UNITED STATES PATENT AND TRADEMARK OFFICE

APPLICATION NO.	FILING DATE	FIRST NAMED INVENTOR	ATTORNEY DOCKET NO.	CONFIRMATION NO.
10/067,992	02/08/2002	Takafumi Nakahama	065905-0248	9942

Office Action Summary	Application No. 10/067,992	Applicant(s) NAKAHAMA, TAKAFUMI	
	Examiner Tho v. Duong	Art Unit 3743

DETAILED ACTION

Figure A: The modified figure corresponds to Figure 1A with limitation shown

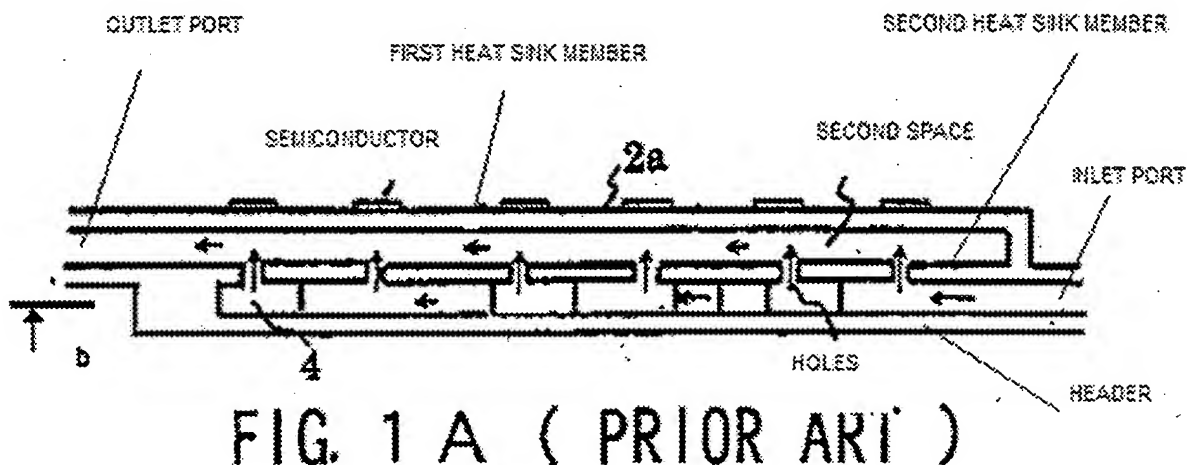
Claims 2 and 18-19 are rejected under 35 U.S.C. 102(a) as being anticipated by applicant's admitted prior art (AAPA). Applicant discloses a prior art (figures 1A and A as bellow) that read on the claimed invention. The prior art further discloses (figure 1C) the claimed subject matter of applicant's claim 18.

Figure A: The modified figure corresponds to figure 6 with limitation shown.

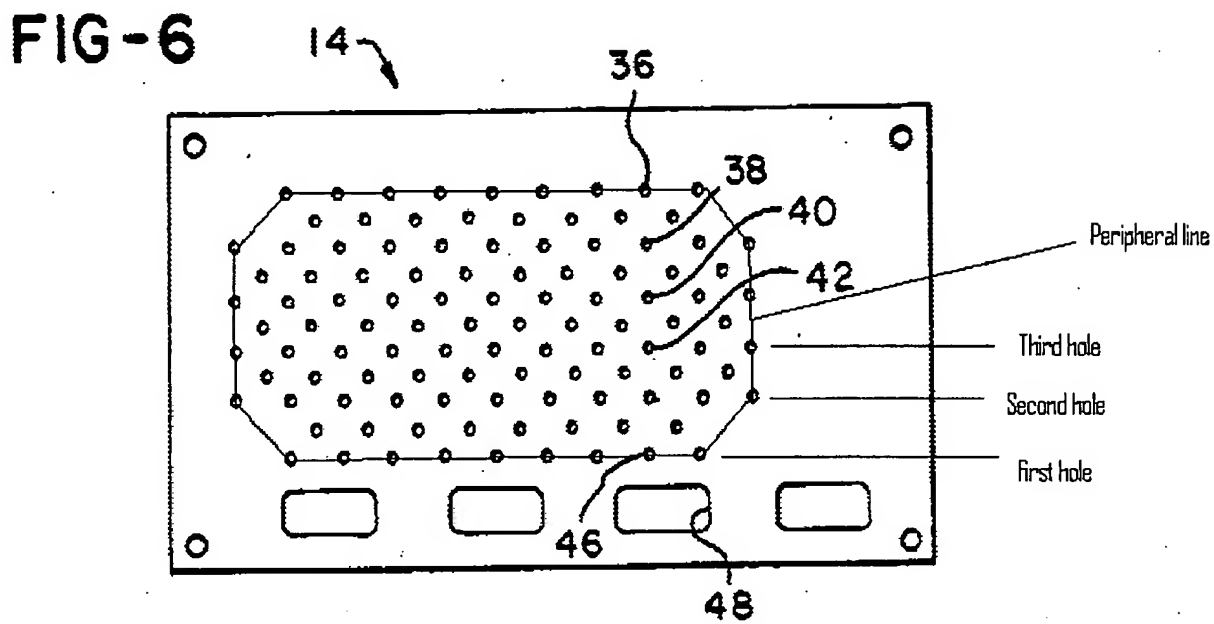
Claims 2 and 18-19 are rejected under 35 U.S.C. 103(a) as being unpatentable over Quon et al. (US 5,316,075) in view of Frey et al. (US 5,978,220). Quon discloses (figure 1, column 2, lines 35-69 and column 2, lines 47-48) a cooling device (10) for a heat source comprising a heat sink including a coolant, the heat sink comprising a first heat sink member (16) with a semiconductor device (18) arranged at an outer surface of the first heat sink member (16) and a second heat sink member (14) provided with a plurality of holes (36-46) in which the coolant that cools the heat source being made to pass through the holes (36-46). The cooling device (10) further comprises a header (12) configured to an opposite side to the heat sink member (16) about the second heat sink member (14) as an axis; an inlet port (26) whereby the coolant is made to flow into a first space (28) surrounded by the header and the second heat sink member (14); and an outlet port (48 or 34) whereby the coolant in a second space (50) surrounded by the first heat sink member (16) and a second heat sink member (14) is made to flow out. As regarding claim 18, Quon discloses (figure 6 and figure A) that the plurality of holes comprises a first hole, a second hole and a third hole arranged in sequence along a peripheral line without intervening holes and wherein the distance between the first hole and the second hole is different than the distance between the second hole and the third hole. Quon does not disclose that the semiconductor module (18) has a plurality of semiconductors for cooling. Frey discloses (figure 1 and column 1, lines 5-30 and column 4, lines 2-17) a cooling system that has a semiconductor module (14) having a plurality of semiconductors (8a-h) forming a logical functional unit mounted on an outer surface of a heat sink (1) for the purpose of cooling at least a logical functional unit used in industrial drives. Since Quon and Frey are both from the same field of endeavor and/or analogous art, it would have been obvious to one having ordinary skill in the art

to use Frey's teaching in Quon's cooling system for the purpose of cooling at least a logical functional unit used in industrial drives.
